ACCESS REPORT

BOARDING HOUSE BUILDING

71-73 THOMAS STREET PARRAMATTA

PREPARED FOR AUSINO GROUP

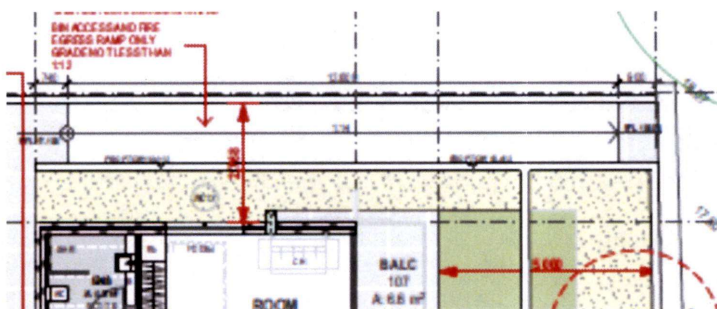
The proposed ramp that is on the north western boundary is noted to be a 1:12 ramp that will only be used for egress only and for wheeling out the bins to the street.

The length of the ramp is at approximately 14m to which does not comply with AS 1428.1

This non-compliance with the Deemed to Satisfy provisions will be subject to an performance solution to address the relevant Performance Requirements of the BCA as advised by the client.

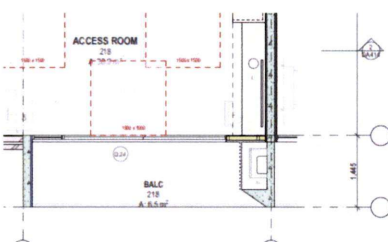
Turning space to the laundry areas to 3 accessible rooms does not provide a compliant 1550mm turning space in front of it. It is recommended that the basin is relocated to another position.

Complying turning space on the balcony is not provided with a 1540mm x 2070mm as per AS 1428.1. This non-compliance with the Deemed to Satisfy provisions will be subject to a performance solution to address the relevant Performance Requirements of the BCA as advised by the client.

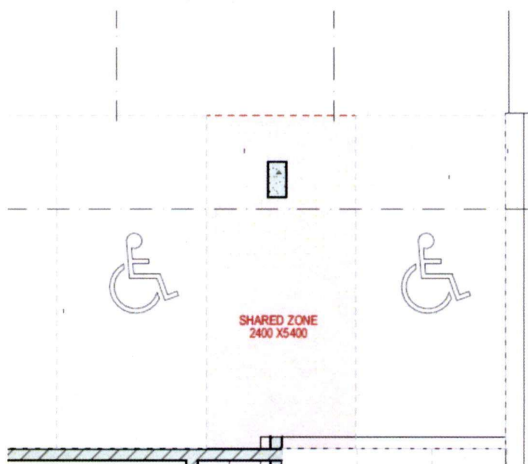
The shared space has a concrete located with the shared that is located where the required bollard is required, to which it does not comply with AS2890.6-2009.

This non-compliance with the Deemed to Satisfy provisions will be subject to an performance solution to address the relevant Performance Requirements of the BCA as advised by the client.
